PSA-17-3 AMENDMENT

AMENDMENTS TO THE PLANNING SCHEME ORDINANCE

Hobart Interim Planning Scheme 2015

Figure 22.6

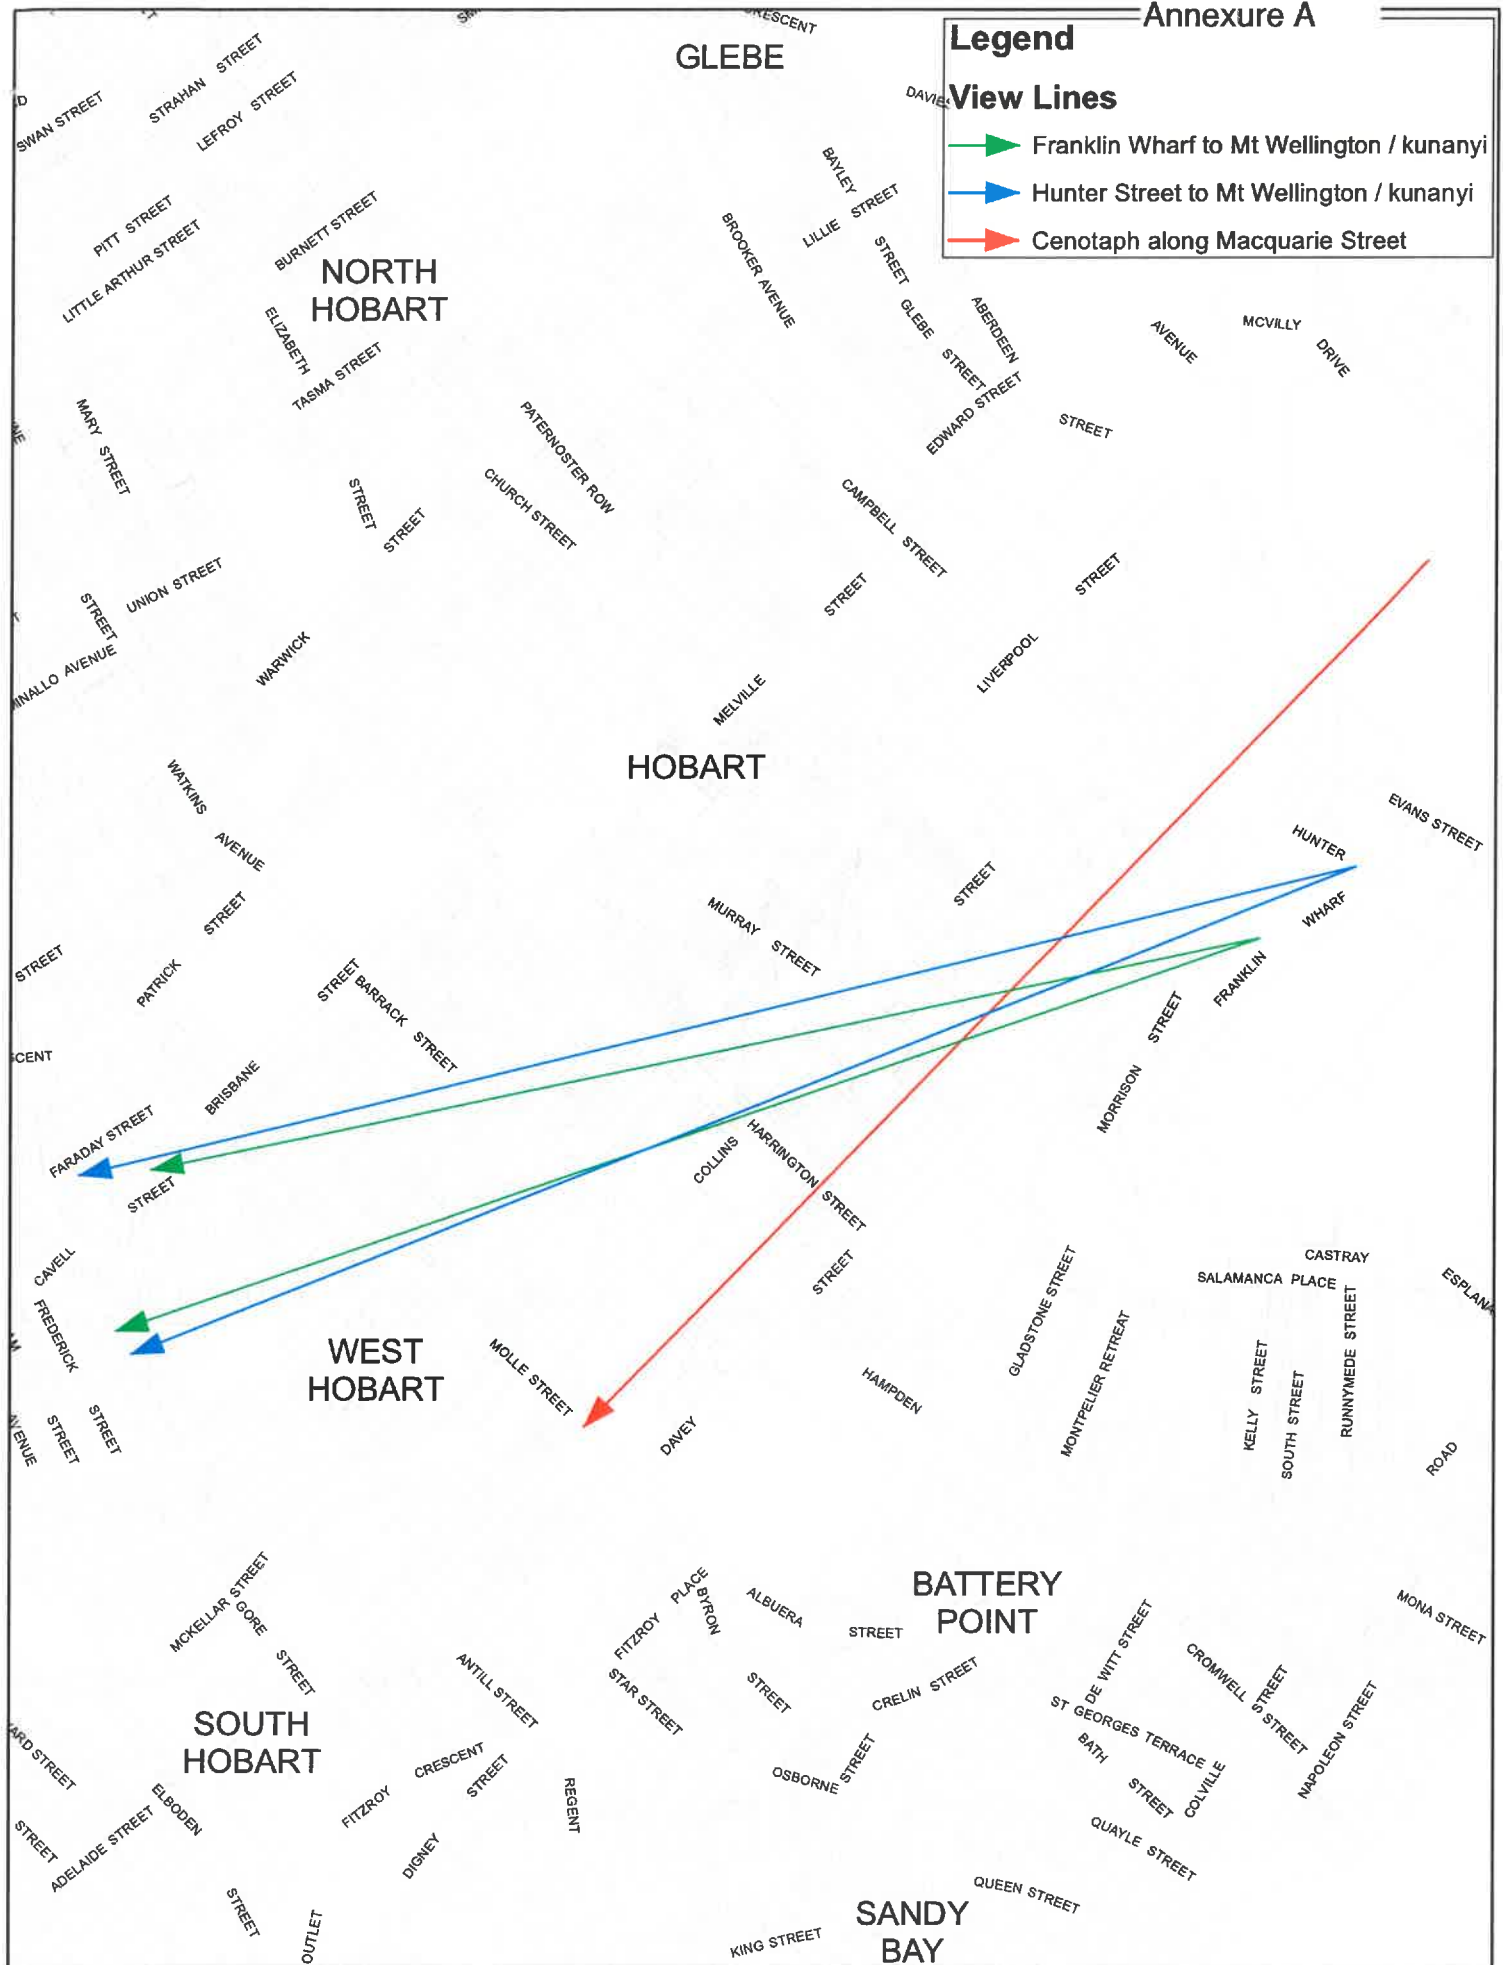
(iv) it does not obscure or negatively impact on the view lines identified in Figure 22.6 or the landscape horizons to Mt Wellington / kunanyi and the Wellington Range from public spaces within the Central Business Zone; and

- (g) providing permeability in support of the open space network and diverse street vistas; and
- (v) it does not obscure or negatively impact on the view lines identified in Figure 22.6 or the landscape horizons to Mt Wellington / kunanyi and the Wellington Range from public spaces within the Central Business Zone; and
- (vi) it is consistent with the Desired Future Character Statements in clause 22.3.1.

Insert Figure 22.6 after Figure 22.5ii as provided in Annexure A.
